Access Compliance Report

Public Rights-of-Way

(Curb Ramps)

Intersection ID: 14530	Main Street: E_5TH_ST	Cross Street: N_LAUREL_AV	Location: NW
ADA ID: 9EF986E92D21	Ramp Type: BlendTrans2	Initial Pass/Fail: Fail	Overall Compliance: No
Severity Score: 1.25			
Codes/Mitigation Info/Possible Solution		Field Measurements/Component Compliance

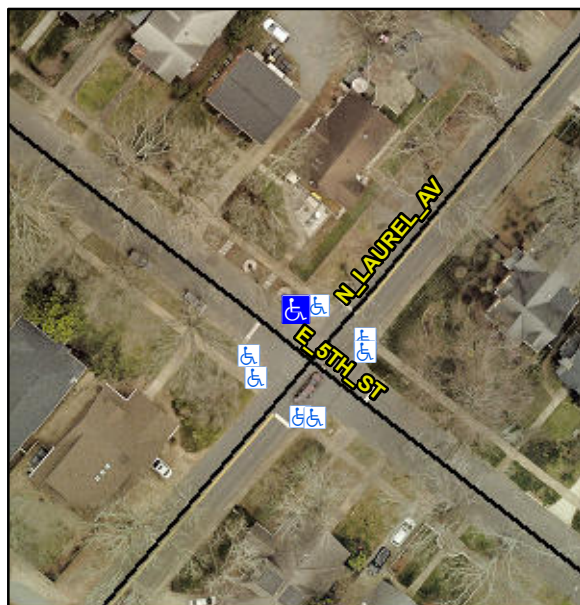
R304.5.3

Compliance	Description	Data	Compliance	Description	Data
N/A	Ramp Length (in)	93.0	Yes	BlendTrans Slope (%)	3.1
Yes	Ramp Width (in)	48.0	No	BlendTrans XSlope (%)	2.3
N/A	Flare Type LT	N/A	N/A	Flare Type RT	N/A
N/A	Flare Slope LT (%)	N/A	N/A	Flare Slope RT (%)	N/A
N/A	Flare Traversable LT?	N/A	N/A	Flare Traversable RT?	N/A
N/A	Landing Length (in)	N/A	N/A	DWS Provided?	N/A
N/A	Landing Width (in)	N/A	N/A	DWS Contrast?	N/A
N/A	Landing Slope (%)	N/A	N/A	DWS Length (in)	N/A
N/A	Landing X Slope (%)	N/A	N/A	DWS Full Width?	N/A
N/A	Landing Curb? (Y/N)	N/A	N/A	DWS Offset (in)	N/A
N/A	Shared Landing?	N/A			
N/A	Gutter Ponding?	Yes	N/A	Gutter Slope (%)	N/A
N/A	Gutter Lip Ht (in)	N/A	N/A	Gutter X Slope (%)	N/A
N/A	Painted X Walk1?	No	N/A	Painted X Walk2?	N/A
	X Walk 1 Direction	To SW		X Walk 2 Direction	N/A
	X Walk 1 Width (in)	N/A		X Walk 2 Width (in)	N/A
	X Walk 1 Slope (%)	1.6		X Walk 2 Slope (%)	N/A
	X Walk 1 X Slope (%)	0.7		X Walk 2 X Slope (%)	N/A

Remove & Replace Curb Ramp With Two New Directional Ramps or Equivalent.
